Access Compliance Report

Public Rights-of-Way

Intersection ID: 48943	Main Street: CALDWELL RIDGE PY	Cross Street: MORGAN LEE AV	Location:	N
ADA ID: 99A7F048F5E5	Ramp Type: BlendTrans1	Initial Pass/Fail: Fail	Overall Compliance: No	Severity Score: 8.75

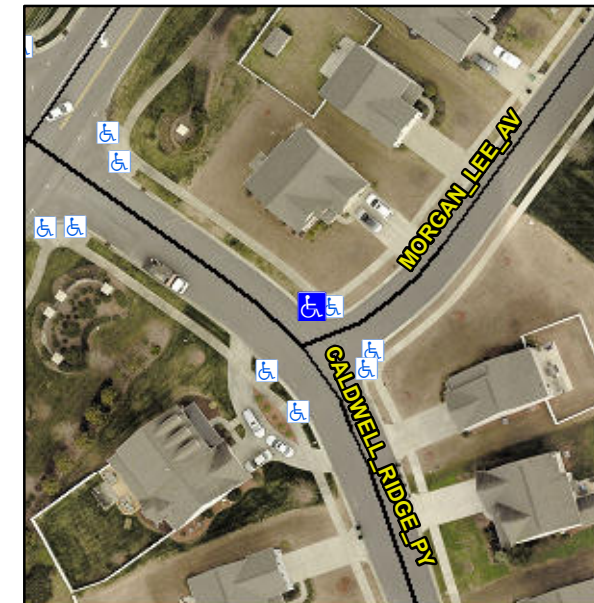
Not Found, R304.5.1

Compliance	Description	Data	Compliance	Description	Data
N/A	Ramp Length (in)	71.5	Yes	BlendTrans Slope (%)	3.9
No	Ramp Width (in)	46.5	Yes	BlendTrans XSlope (%)	2.0
N/A	Flare Type LT	N/A	N/A	Flare Type RT	N/A
N/A	Flare Slope LT (%)	N/A	N/A	Flare Slope RT (%)	N/A
N/A	Flare Traversable LT?	N/A	N/A	Flare Traversable RT?	N/A
N/A	Landing Length (in)	N/A	N/A	DWS Provided?	N/A
N/A	Landing Width (in)	N/A	N/A	DWS Contrast?	N/A
N/A	Landing Slope (%)	N/A	N/A	DWS Length (in)	N/A
N/A	Landing X Slope (%)	N/A	N/A	DWS Full Width?	N/A
N/A	Landing Curb? (Y/N)	N/A	N/A	DWS Offset (in)	N/A
N/A	Shared Landing?	N/A			
N/A	Gutter Ponding?	N/A	N/A	Gutter Slope (%)	N/A
N/A	Gutter Lip Ht (in)	N/A	N/A	Gutter X Slope (%)	N/A
N/A	Painted X Walk1?	No	N/A	Painted X Walk2?	N/A
	X Walk 1 Direction	To SW		X Walk 2 Direction	N/A
	X Walk 1 Width (in)	N/A		X Walk 2 Width (in)	N/A
	X Walk 1 Slope (%)	1.8		X Walk 2 Slope (%)	N/A
	X Walk 1 X Slope (%)	0.5		X Walk 2 X Slope (%)	N/A

Remove & Replace Curb Ramp With Two New Directional Ramps or Equivalent.
